2190157
6 May 2020

**DA/585/2019 - Response to Request for Additional Information
Liverpool Civic Place Concept Development Application
52 Scott Street, Liverpool**

Figure 1 Weekday reduction in Scott Street shared zone traffic (blue zone indicates reduction)

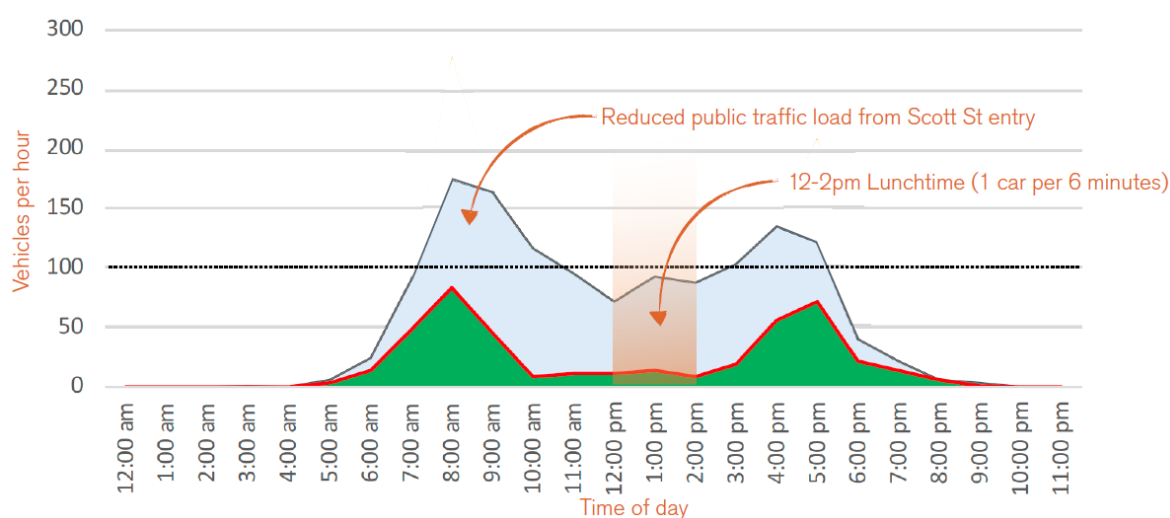
*“Access from Terminus Street is for one (1) driveway for entry and exit movements; in a forward direction. The access is provided for **servicing requirements only** and it not provided for commercial, retail or residential access. The access is not to be linked within the building to other parts of the underground carpark”.*

Following receipt of this letter, discussions with RMS continued and an in-principle agreement was reached¹. This involved permitting restricted private vehicle (approximately 200 cars TBC) and service vehicle access from Terminus Street, providing that Council could demonstrate accommodation of the RMS proposed six lane configuration along Terminus Street, which was previously submitted to the RMS. As a result, the Applicant has directly responded to Architectus’ request to limit vehicle access from Scott Street to ensure the quality and function of the public domain is not compromised. As stipulated in the Revised Traffic Impact Assessment (**Attachment F**), there is a significant reduction in vehicle use and pressure on the Scott Street shared way (refer to **Figure 1**), specifically:

- An hourly average of 1 vehicle every 43 seconds.
- Vehicle movements more than halved during morning and afternoon peaks.
- 1 car per 6 minutes average through the lunch period when the public domain would be at its busiest.
- The road carries less than 100 vehicles per hour and is considered suitable for use as a Shared Zone (RMS Guidelines have removed traffic rates for shared zones).

Figure 3 Revised Concept proposal public domain layout

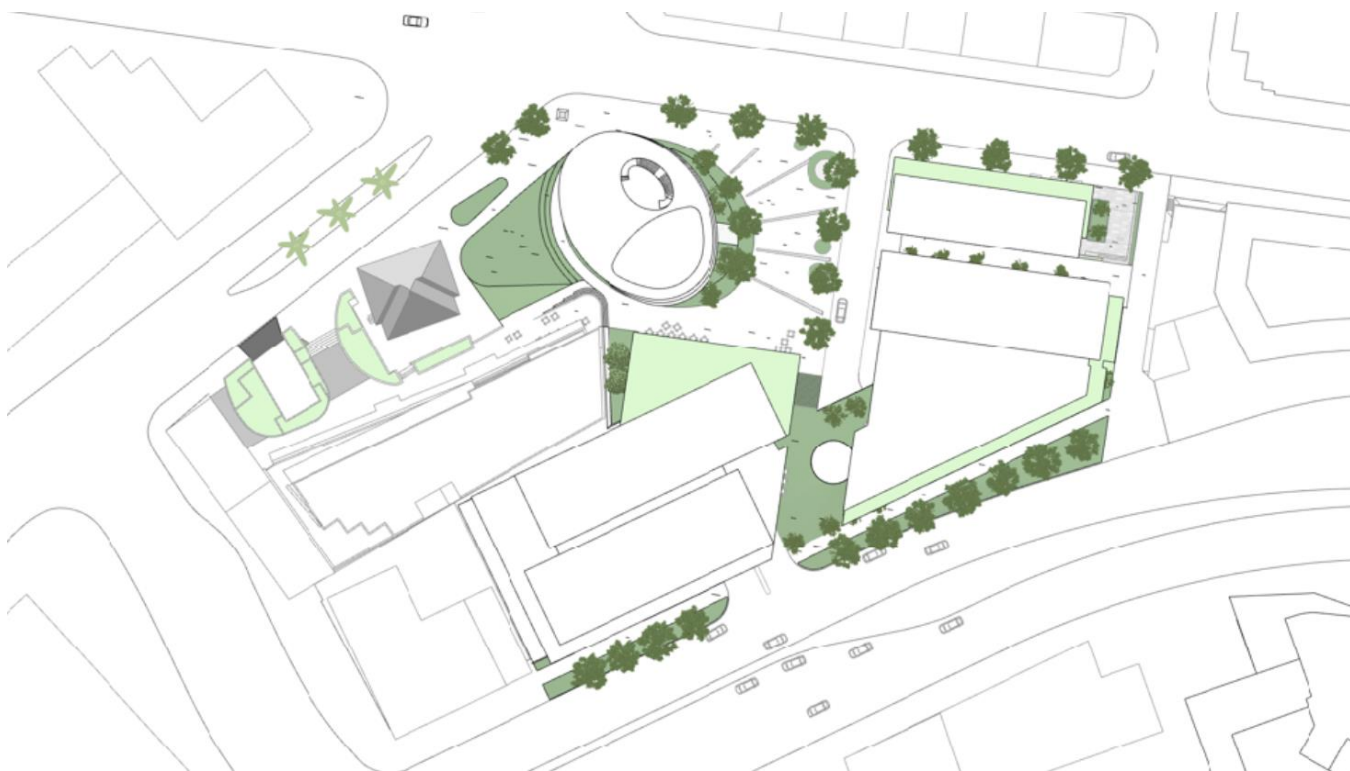
Throughout the assessment of the Concept Proposal, Architectus and the DEP maintained concerns with the public domain design, in particular the folded ground plane. Specifically, the following was noted:

“The proposed public domain envelope as provided in the Concept DA provides for only the internal street, and the incidental space between buildings to be provided as public space. As previously advised, this does not appear to create a great space for activities, gathering or planting”.

“The new public plaza should be located at street level on Macquarie and Scott Streets and provide an appropriately designed termination to Macquarie Street. Secondary public places at the upper, entry level to the council office tower should be of a scale suited to a civic building and provide opportunities for passive and active use during peak times. The plaza should be large enough for major public gatherings, events and civic occasions (1200-1500m²)”.

In response to this, the Applicant worked closely with FJMT and Ethos Urban to develop an alternative that could capitalise on the opportunities generated by the amended vehicle access strategy detailed at **Section 1.1**. The result is an at grade expanse of public domain with a combined area of approximately 5,400m² or 59% of the total site area (refer to **Figure 3**). The public domain strategy considers varied experiences and landscaped features for components of the public domain, as detailed over the page.

Civic Square: an activated hardscape comprising approximately 1,200m² (1,600m² with temporarily closed shared way) at grade, improving its useability and connectivity to surroundings. This area will be self-activated by pedestrians and landscape features and will be an optimal area to accommodate public and civic events, in accordance with Council fixtures. This area is the gateway to the site and is further activated by ground floor civic and retail uses with a direct interface to the square.

Figure 9 Library envelope axis rotation

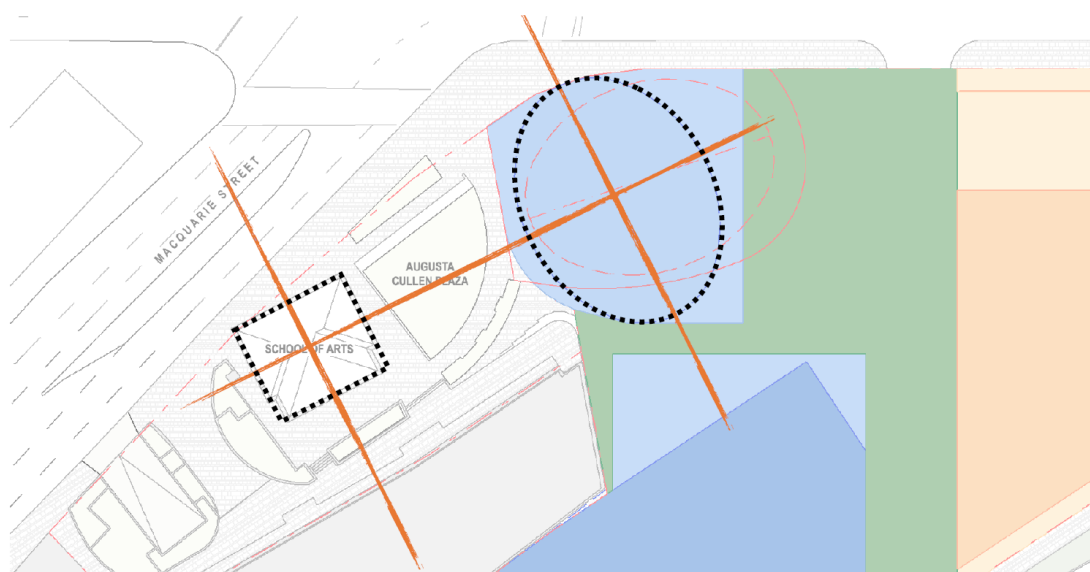
The reconfiguration of the public domain has resulted in opportunities to enhance the design of the future library building. As reflected in the DEP's feedback, key to this redesign was ensuring that both the public domain and landmark library building shared a strong presence at the terminus of Macquarie Street. In addition, it was recognised that the library building should maintain a sympathetic relationship with the neighbouring heritage listed School of Arts building.

In this regard, the library envelope axis has been rotated as an urban design gesture to the School of Arts Building as illustrated at **Figure 9**. This design move also frees up area to the east and west of the library envelope to embellish the civic square and civic green public domain elements. As such, when the site is viewed from Macquarie Street, the library maintains presence at the top of Macquarie Street as the City's civic anchor, surrounded by strong heritage and public domain features (refer to **Figure 10**).

Figure 11 Lodged (left) and amended (right) library envelope

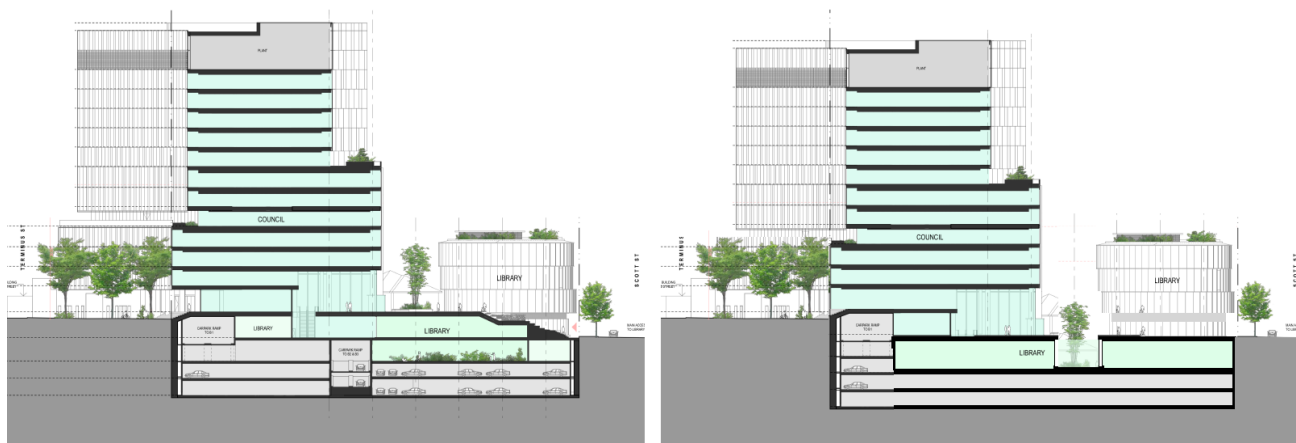
The requirement to accommodate an at grade civic square, had implications on the library configuration and program. As illustrated at **Figure 11**, the subterranean library levels have been reconfigured whilst generally maintaining the height of the above ground library envelope. This redesign was undertaken following close consultation with current Council's library staff to ensure it not only responded to Architectus and the DEP's feedback, but it could also meet the library staff's functional requirements.
